Unique Randomizer Initialization for Interference Management in 802.16 OFDM PHY

Document Number: IEEE S802.16d-04/37r1

IEEE C802.16d-04/37r1

In an interference scenario, a user can misinterpret someone else's data as his data. To prevent this misinterpretation, the randomizer is initialized properly with the base station identifier.

Randomizer Initialization

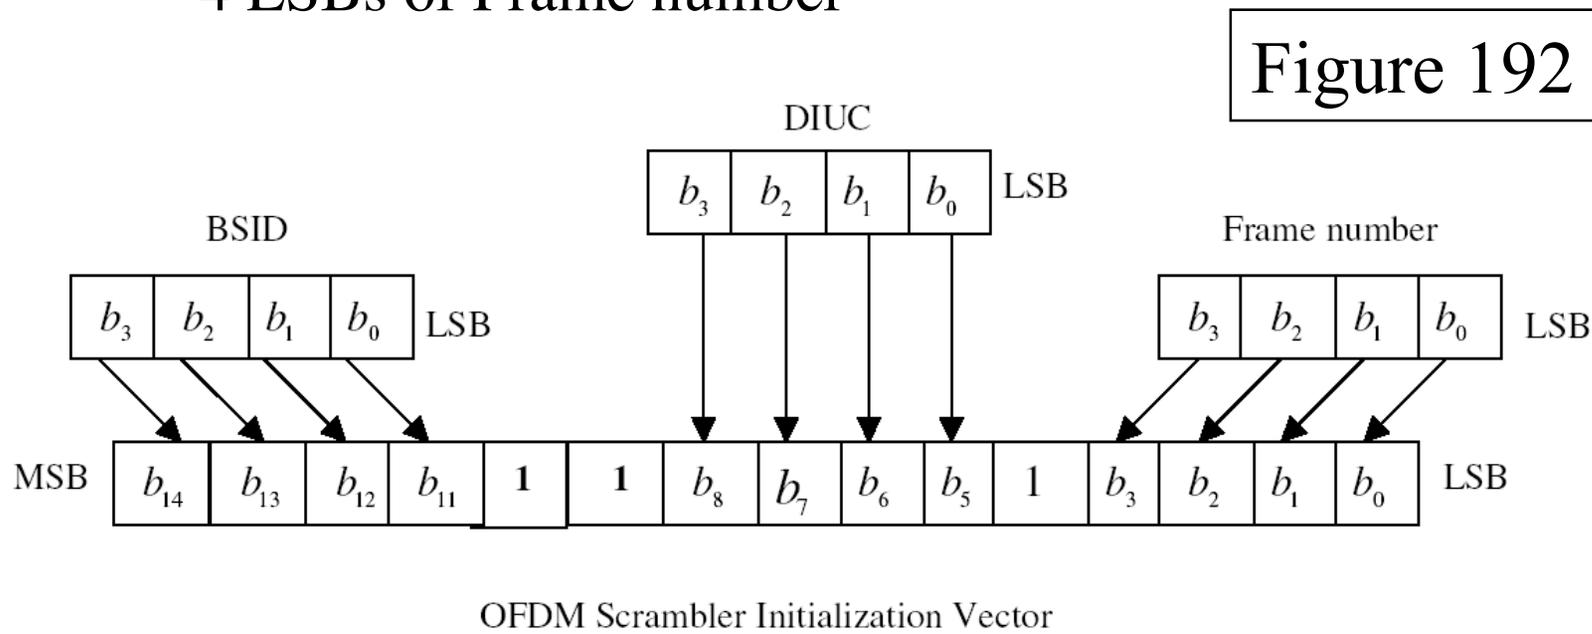
- BS unique identifier:
 - BSID is 48 bits long (upper 24 bits for operator ID and lower 24 bits unique to a BS)
 - Propose to use the lowest 4 bits of BSID to seed the randomizer
 - Provides a virtual cluster of 16 BSs

Figure 193

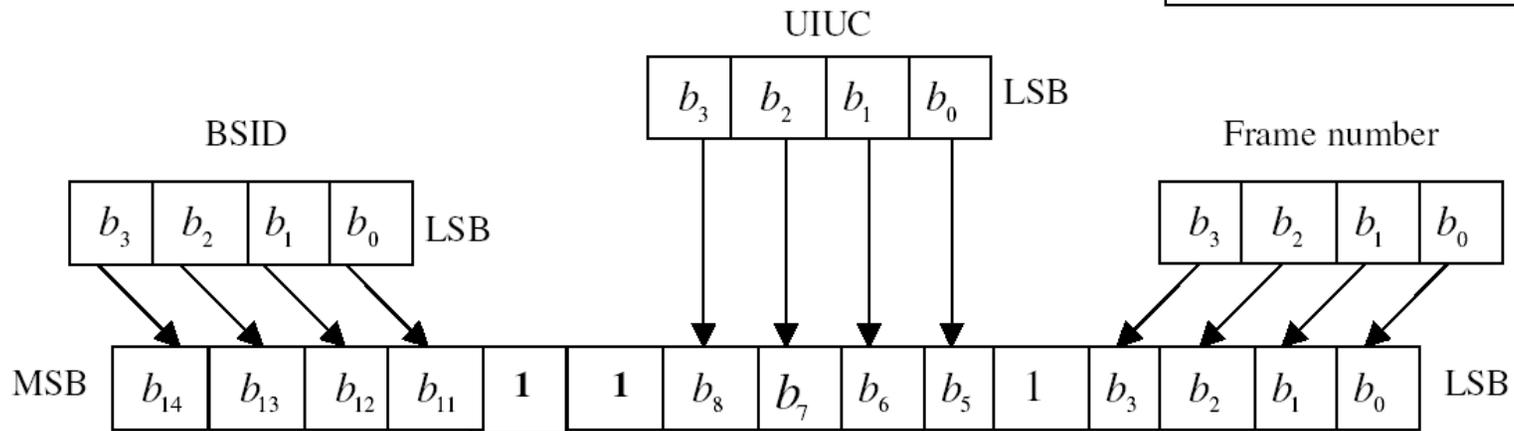
Uplink Randomization

- Uplink randomizer is initialized with:
 - 4 LSBs of BSID
 - 4 bits of UIUC
 - 4 LSBs of Frame number

2) The paragraph immediately above Figure 193 is changed to read:

“On the uplink, the randomizer is initialized with the vector shown in Figure 193. **The OFDM symbol number (i.e. the number of the first OFDM symbol of the allocation) shall be counted from the time instant pointed by Allocation Start Time field of the UL-MAP, the first symbol being counted as symbol #0.**”
